Network Working Group
Request for Comments: 175
NIC 7074

Comments on "Socket Conventions Reconsidered"

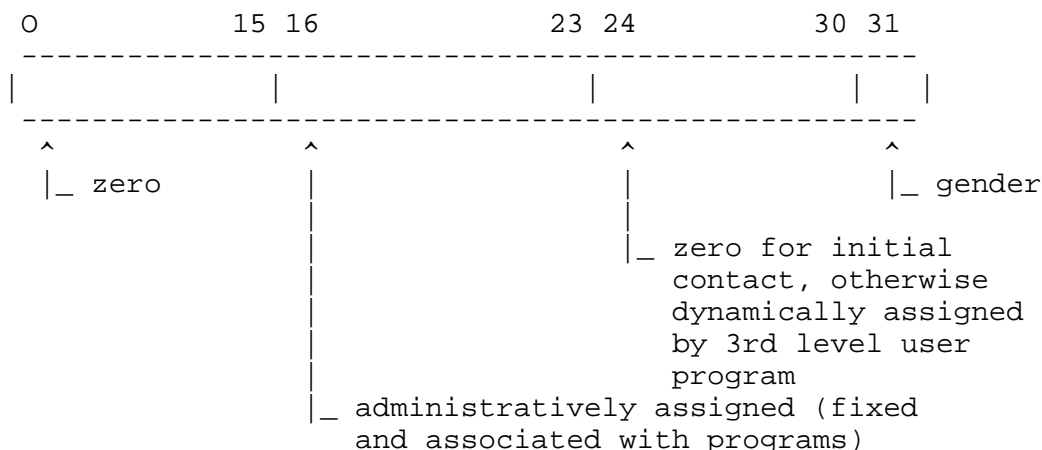
Our main departure in thinking from RFC #167 concerns the socket length. (See RFC #164, page 21.) Since there is an apparently serious TIP storage consideration, Rand- assigned sockets will have the high-order 16 bits zero.

For the particular programs (current and pending) that Rand must access, repeatability of socket name (RFC #167, page 3) is not necessary for the user process and also not necessary for the server process except for initial contact (ICP) sockets.

Our current use of socket names is diagrammed below.

(NOTE: This scheme corresponds exactly with both UCSB and UCLA/CCN conventions).
